**TOWN OF NEWBURGH
PLANNING BOARD
TECHNICAL REVIEW COMMENTS**

PROJECT: NEWBURGH PARK ASSOCIATES (NPA) SITE PLAN
PROJECT NO.: 17-03
PROJECT LOCATION: SECTION 89, BLOCK 1, LOT 80.1 & 80.2
REVIEW DATE: 31 DECEMBER 2020
MEETING DATE: 4 JANUARY 2021
PROJECT REPRESENTATIVE: ZEN DESIGN CONSULTANT, INC.

Newburgh Park Associates
Site Plan
SBL: 89-1-80.1 & 80.2

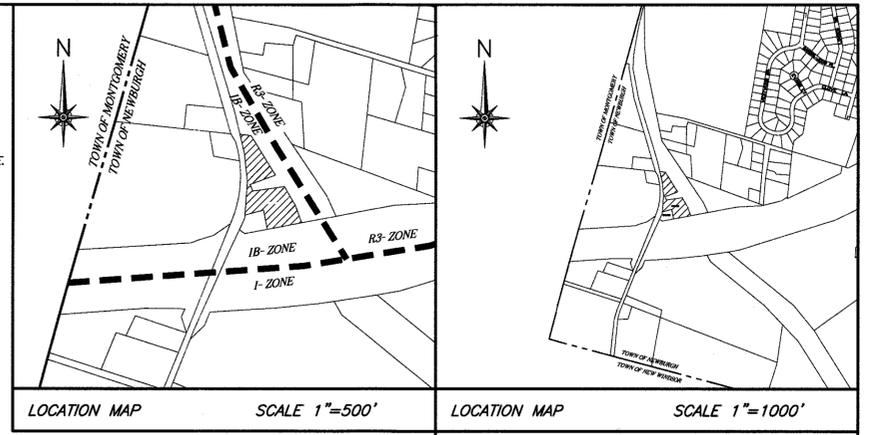
2. *The petroleum storage tanks must be located at least 15 feet from any property line. The storage tanks on the plans last revised on October 11, 2020 do not appear to meet this requirement.* - The tank location has been adjusted to meet this separation requirement.

3. *Additionally, Town Zoning Code 185-28 requires a 15 foot separation between storage tanks and the fuel pump dispensers. The current plan does not appear to meet this requirement.* - The storage tanks have been relocated to meet this separation requirement.

4. *Confirmation of the front yard setback variance previously granted by the ZBA on December 28, 2017 due to the reconfiguration and enlargement of the proposed development: 60 feet is required, 28.8 feet is provided.* - This has now been adjusted to a 25.0' proposed setback.

6. *The front yard setback along Route 747 requires a 60 foot setback to the canopy and 21.8' is proposed - This has now been adjusted to a 25.0' proposed setback.*

7. *For the side of the north canopy, there is a 50 foot setback requirement, and 30 feet is proposed.* - based on the new layout the proposed setback is 21.3'
8. *The rear yard requires 60 feet, and 34.7 feet is proposed* - based on the new layout the proposed setback is 24.5'
9. *The applicant has not yet identified any signage on the canopy. Signage on the canopy is not permitted in the town's signage ordinance. Past applications have been referred to the ZBA for consideration of variances to allow signage on canopies.* - the applicant is putting together the building signage and is planning to submit that material to the ZBA for consideration.

1. 35.0' front yard variance - 747 Blvd. - west side
2. 35.5' rear yard variance - east side
3. 28.7' side yard variance - north side

SURVEYOR ANTHONY D. VALDINA	ENGINEER WILLIAM J. MORREAU	PROPOSED SITE PLAN NEWBURGH PARK ASSOCIATES, INC. EXISTING SITE PLAN SBL: 89-1-(80.1 & 80.2) TOWN OF NEWBURGH, ORANGE COUNTY, NY	
		DATE	SHEET NUMBER
		7/7/2016	1 OF 5
		SCALE	JOB NUMBER
		1"=30'	15-008-PMU

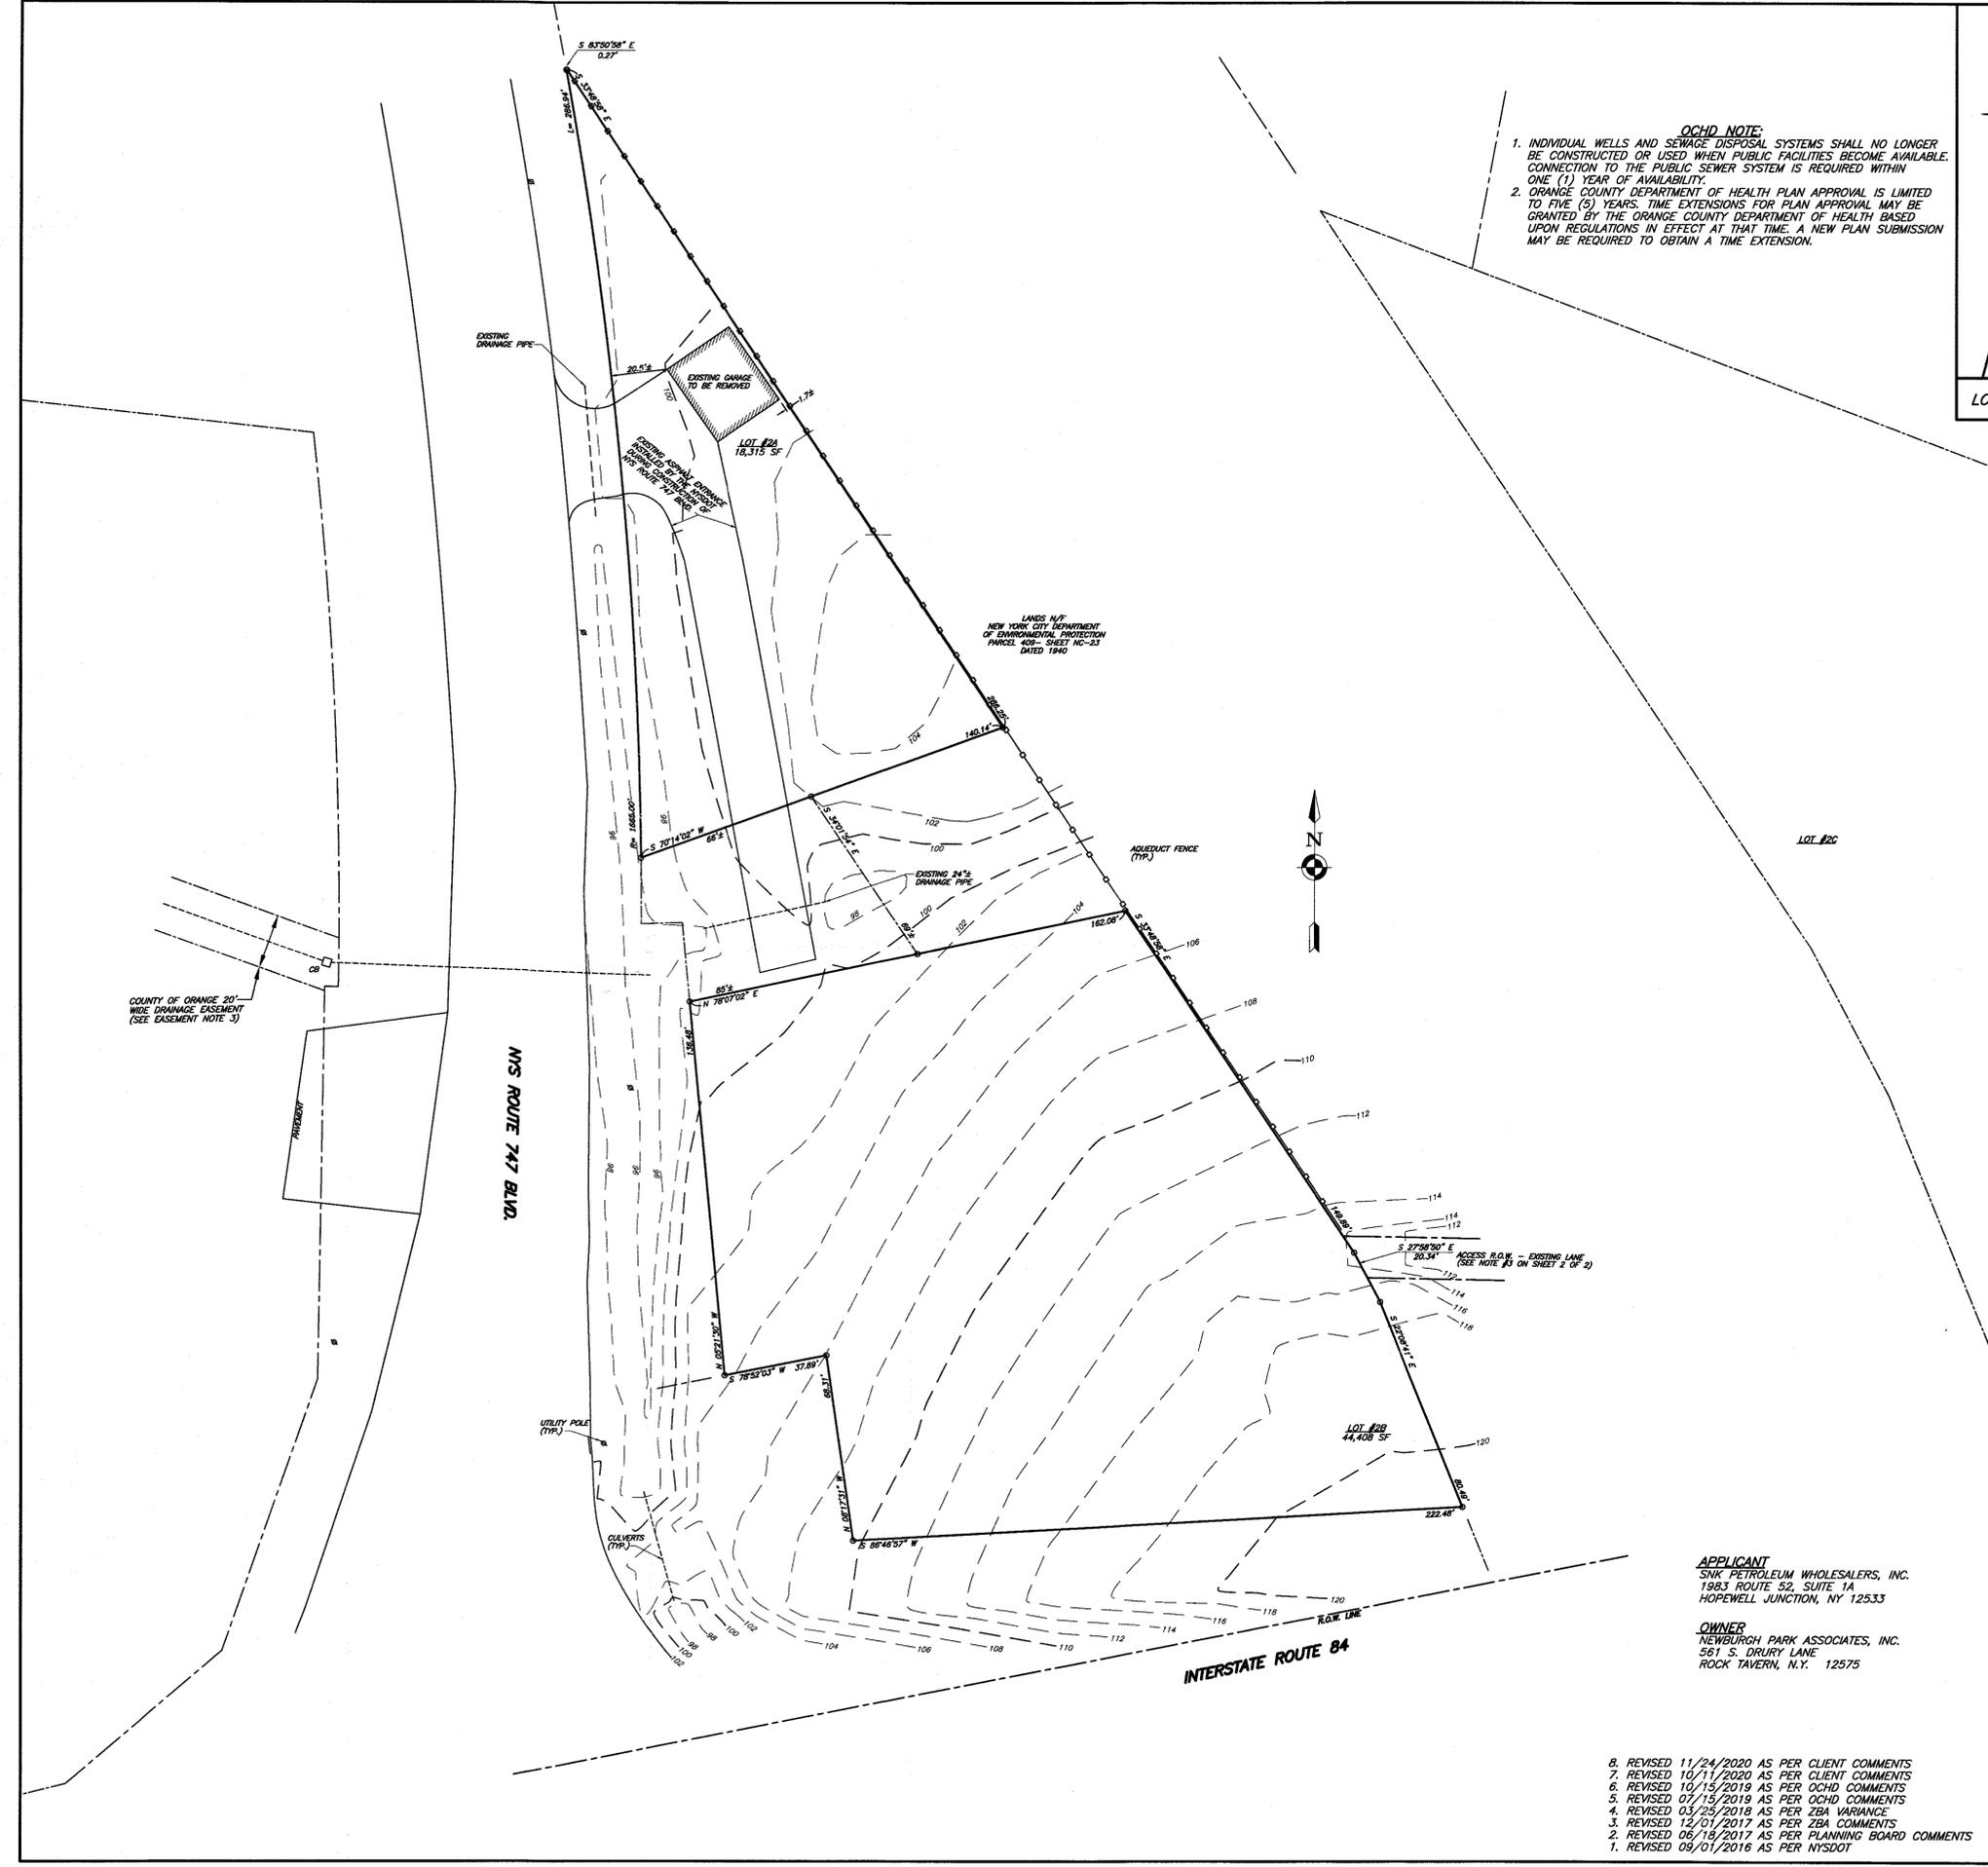
- 1) Front yard setback for canopy. NYS Route 747 -25 feet provided where 60 feet is required.
 - 2) Side yard setback for west canopy. The 3 8+/- feet provided where 50 feet is required.

- 3) Rear yard setback for proposed building. 43.5 feet provided where 60 feet is required.
 - 4) East canopy. 24.5 foot rear yard provided where 60 feet is required.

- 5) East canopy. 21.3 foot side yard setback where 50 feet is required.
2. It is noted that the project site must be addressed as a Stormwater Hotspot under the NYSDEC Stormwater SPDES program. No areas are depicted for stormwater management. Infiltration practices are not permitted for Stormwater Hotspots.

3. Extensive retaining walls are identified on the site. Height of the retaining walls is unknown as no Grading Plan has been produced for the new layout. It is noted that the truck turning movements identify the vehicle maneuvering against the proposed retaining walls in many locations.

4. While an access easement may exist across lands of others between the two parcels it is unclear if utilities including sewer lines and retaining wall structures are permitted based on the access easement.
